Keithley Instruments
28775 Aurora Road
Cleveland, Ohio 44139
1-800-833-9200
tek.com/keithley

Model DMM7510 7½ Digit Graphical Multimeter
DMM7510-NFP
DMM7510-NFP-RACK
DMM7510-RACK

VERSION 1.7.5 RELEASE

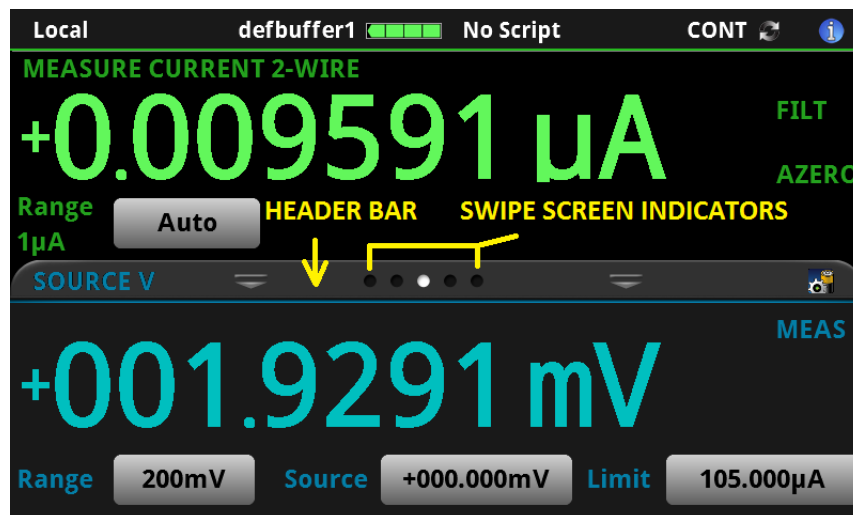
A number of improvements have been made to the overall Graphical User Interface as follows:

1. Screen Colors: All screen colors have been modified for better contrast and easier readability.
2. Pinch-to-Zoom Performance: Throughout the user interface, the “Pinch-to-zoom” touch screen motion has been improved and is more responsive.

5. Graphing:
 - a. New Auto Scale Options (X-Axis) → Track Latest, Track Group
 - b. New Auto Scale Options (Y-Axis) → y-swim lanes, y-shared, y-per trace
 - c. Multi-Trace Line Plots
 - d. Multi-Trace Scatter Plots
 - e. Various refresh and performance improvements

6. Histogram:
 - a. New Auto-Scale, Auto-Bin, and Fit
 - b. SmartScale choose best scaling option
 - c. Various refresh and performance improvements

8. Updated Reading Table: Added new reading table features and a new Reading Preview Graph. Please see the Reference Manual for further details.
